*DHC - 268*

Subject: Administrative Approval  
For Commingling

We request administrative approval for a Pictured Cliffs and Chacra formations commingled completion of the Jicarilla "B" Well No. 5 located in Unit L of Section 32, T25N, R5W, Rio Arriba County, New Mexico.

Jicarilla "B" Well No. 5  
 1050' FSL, 600' FWL, Sec. 32-25N-5W  
 Rio Arriba County, New Mexico  
 Elev. 6700' KB

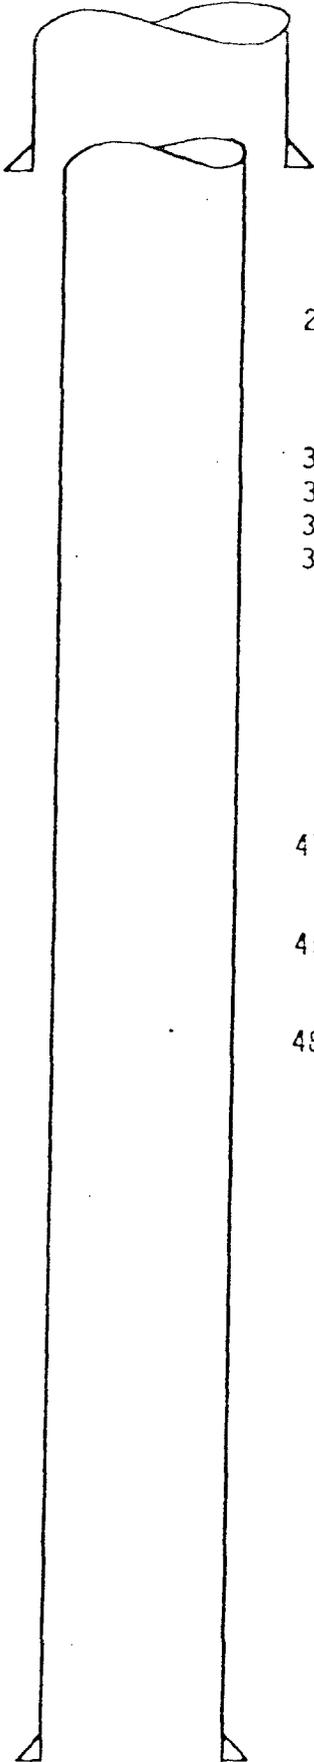
*No PC Pool*

*" Chacra "*

*Let A.K. determine allocation*
